## ADDENDUM NO. 04

Project Name: Aston Township Municipal Complex

Project No.: 2301.00-22

Date of Issue: April 23, 2024

## HIGH ROOF FRAMING PLAN

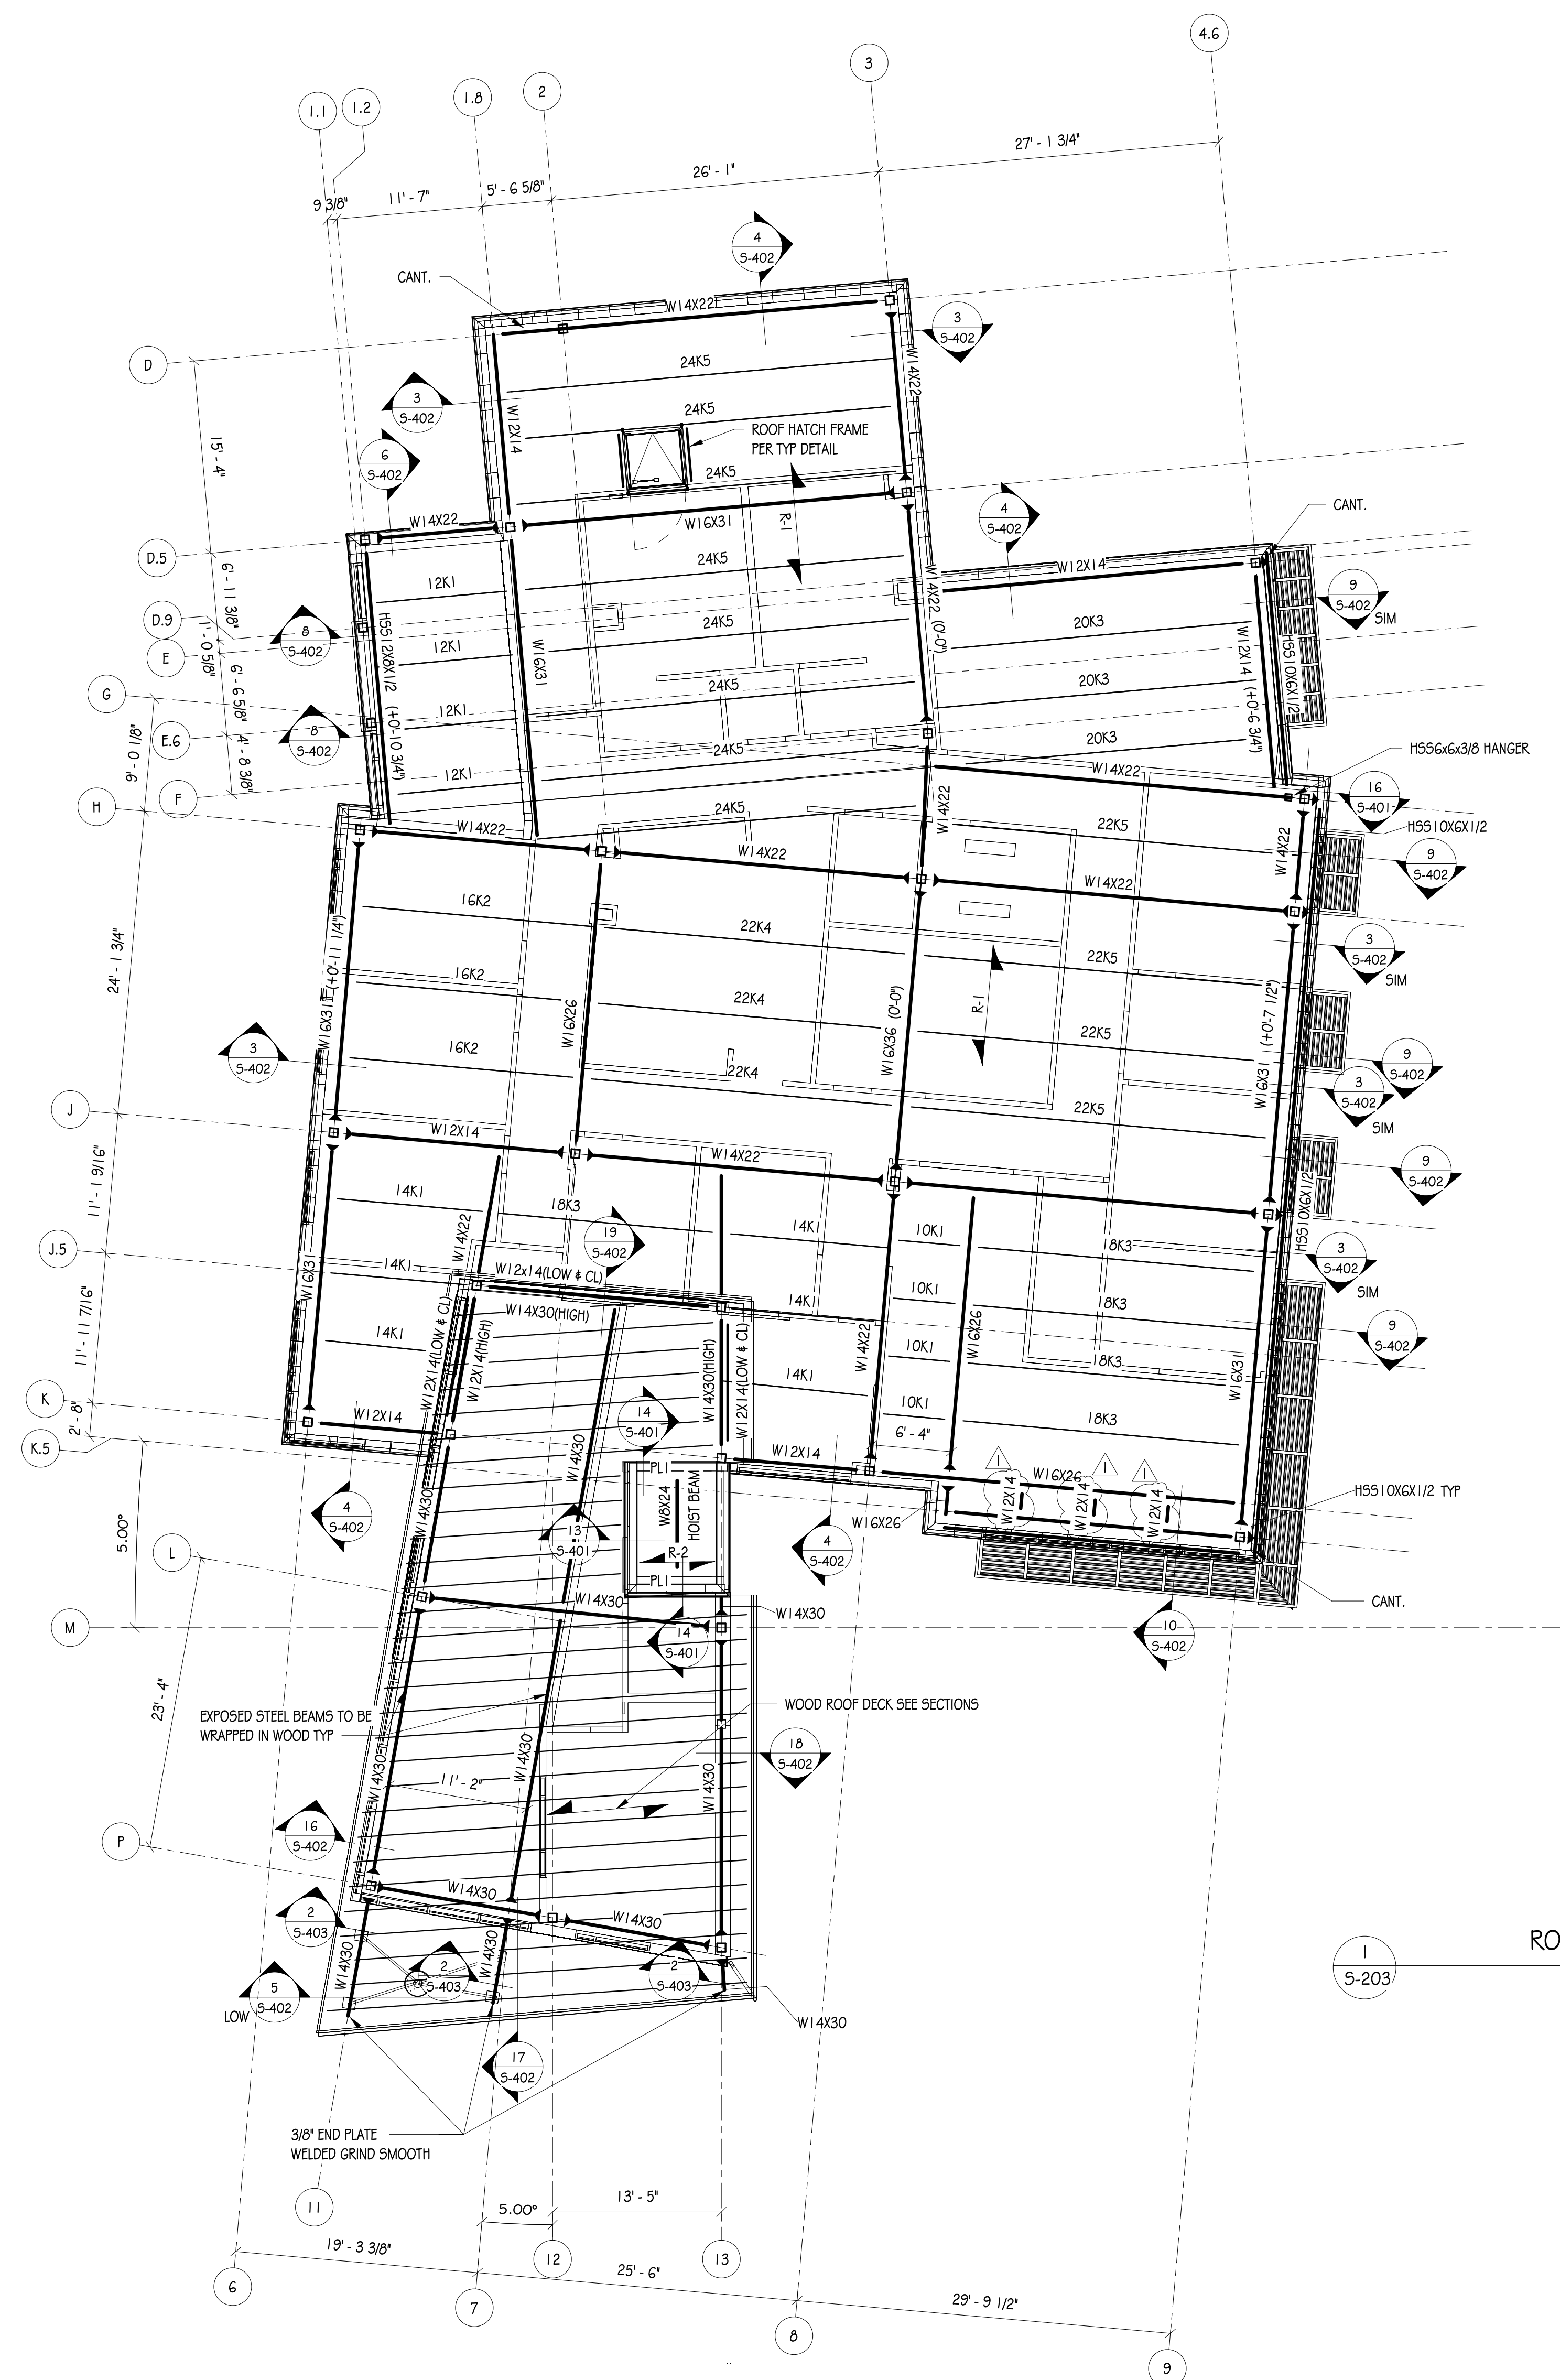
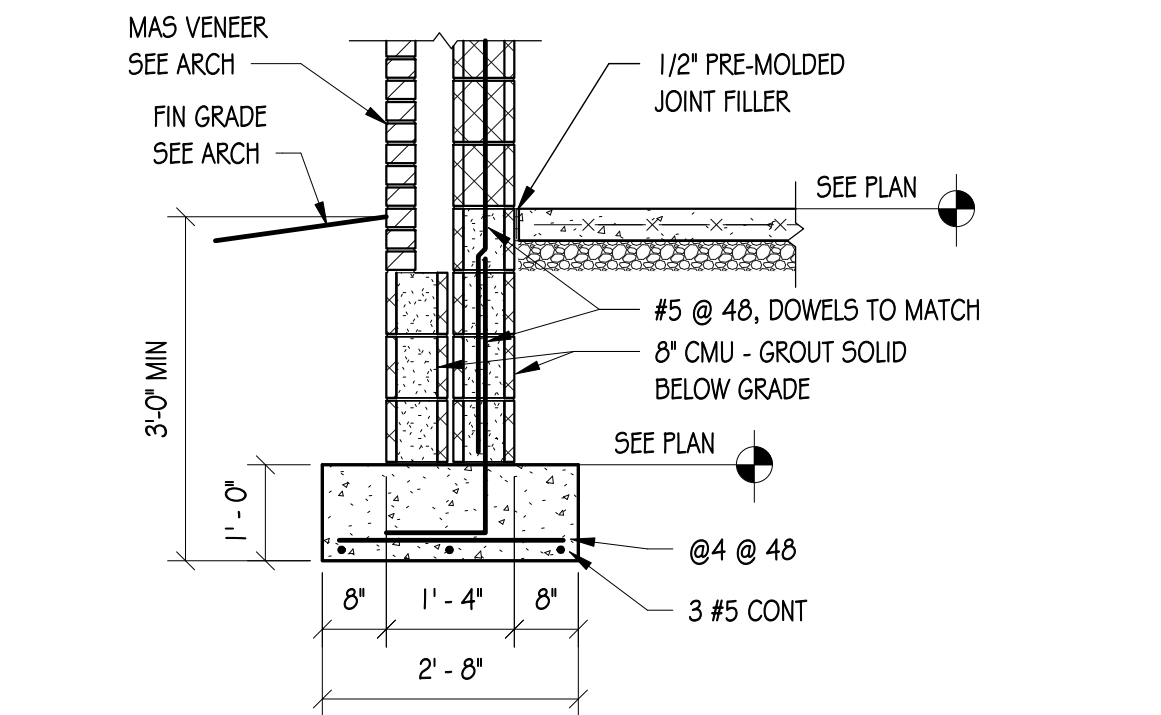
6. Reference to Sheet S-203 – High Roof Framing Plan: Sheet S-203 – High Roof Framing Plan is being reissued as part of this addendum. The following clarifications have been made:

- a. Revised Roof Framing Plan notes.
  - b. Added beam labels above room 221.
7. Reference to Sheet S-301 – Foundation Sections: Sheet S-301 – Foundation Sections is being reissued as part of this addendum. The following clarifications have been made:

**S-401**

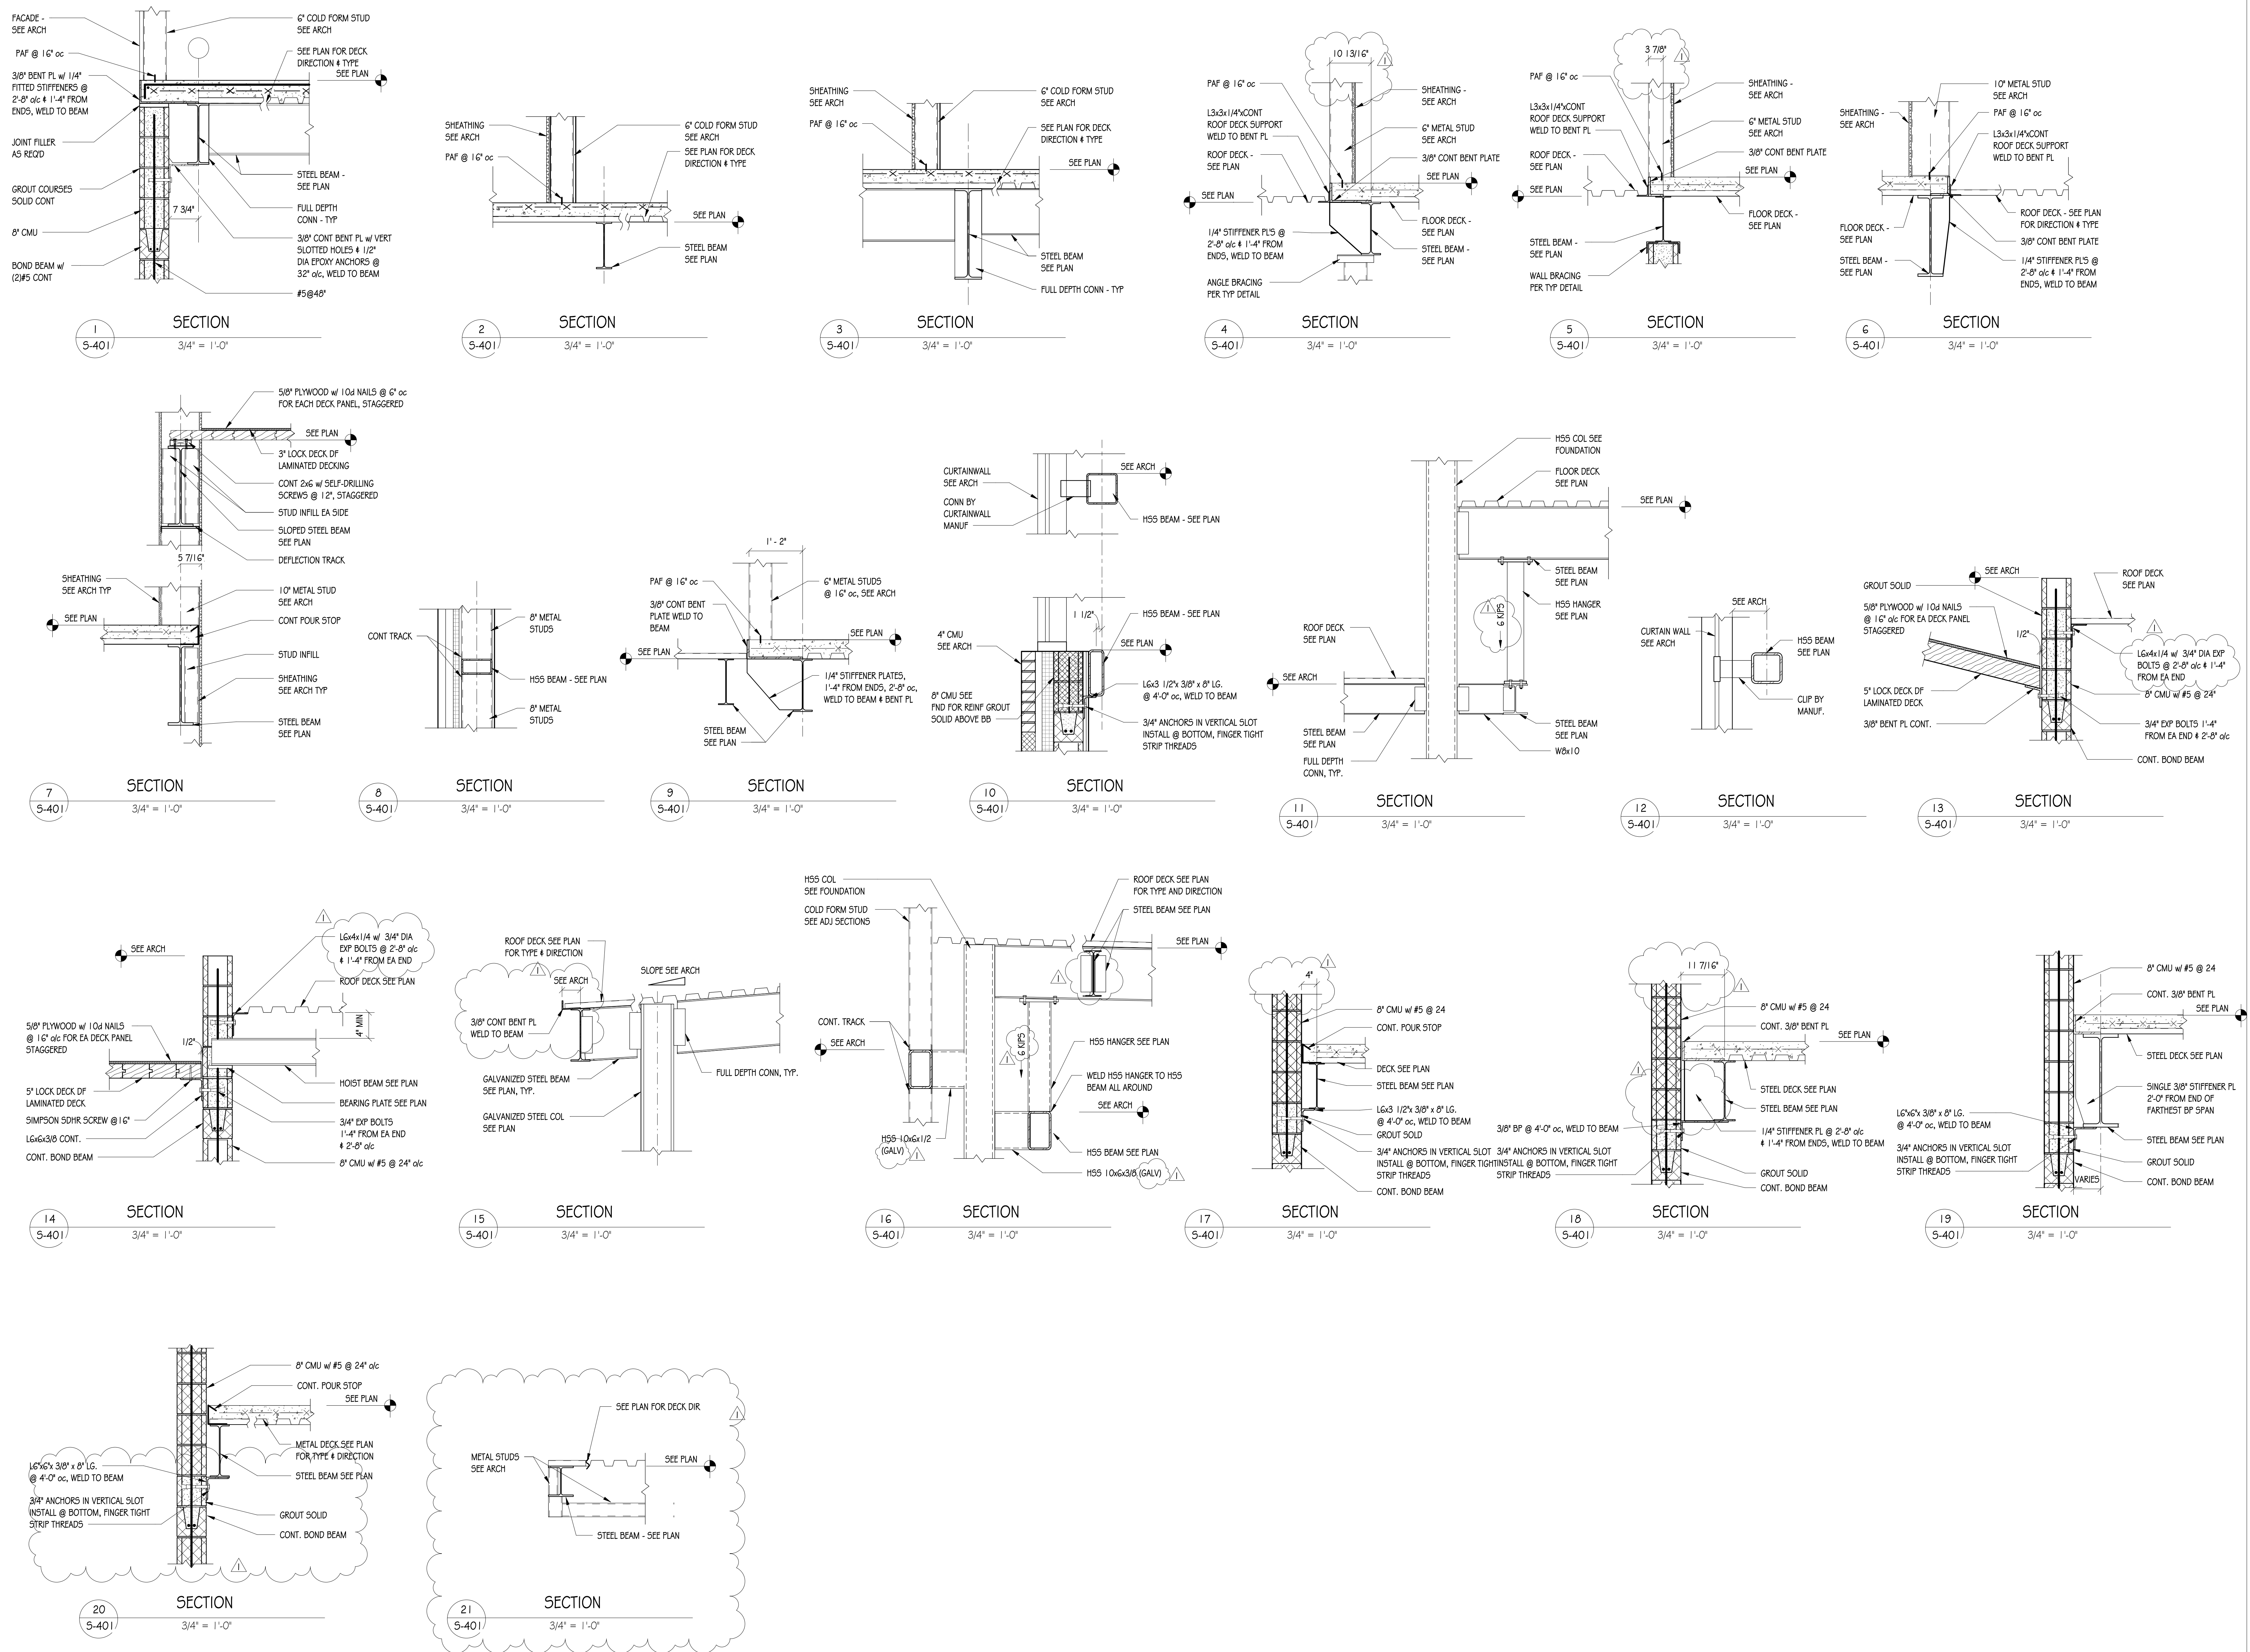
- a. Revision to sections 6, 8, 9, 10, and 13.
  - b. Added sections 15, 16, 16A, 17 and 18.
8. Reference to Sheet S-401 – Framing Sections: Sheet S-401 – Framing Sections is being reissued as part of this addendum. The following clarifications have been made:

- a. Added dimensions to sections 4, 5, 17 and 18.
  - b. Revised hanger load at sections 11 and 16.
  - c. Revised sections 13, 14, 15, 16, and 20.
  - d. Added section 21.
